Comment on “Draft Referral Materials for Cedar LNG Project” on behalf of Douglas Channel Watch

J. David Hughes

Figure 1 – Emissions from the Cedar LNG Project over its proposed 40-year lifespan by component (see Table 1 and Appendix 8B of the Cedar application⁶).

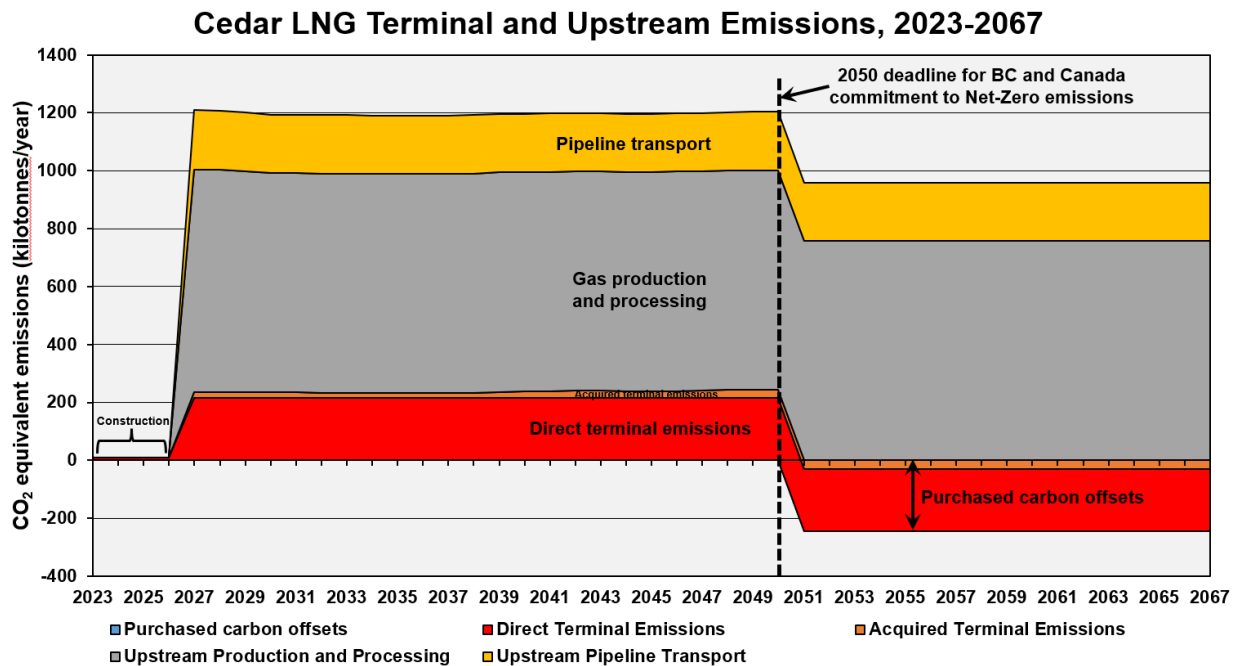
Offset credits according to the SACC can only be applied to terminal emissions and cannot be applied to upstream emissions (section 2.1.4.1⁷). This means that 80% of the Project’s emissions, amounting to nearly one megatonne per year, will be added to B.C.’s total even if sufficient offset credits can be purchased to offset emissions from the terminal itself. Figure 1 illustrates emissions from the Project as projected in the Cedar application, including nearly one megatonne annually from upstream emissions after 2050 when B.C.’s emissions are supposed to be net-zero.

As for the net-zero plan required by the regulations, the Cedar application simply states “*it is assumed that Cedar will purchase offset credits to achieve net-zero in 2050*”. There is no gradual reduction in emissions as 2050 is approached, nor any discussion of how to mitigate upstream emissions. The Cedar application projects emissions at 1.2 megatonnes per year from the start of the Project through 2050 when carbon offsets are purchased to offset terminal emissions, and one megatonne per year thereafter until the Project ends in 2067. Nor is there any discussion in the Cedar application of offset costs, or their possible effect on the Project’s economics.
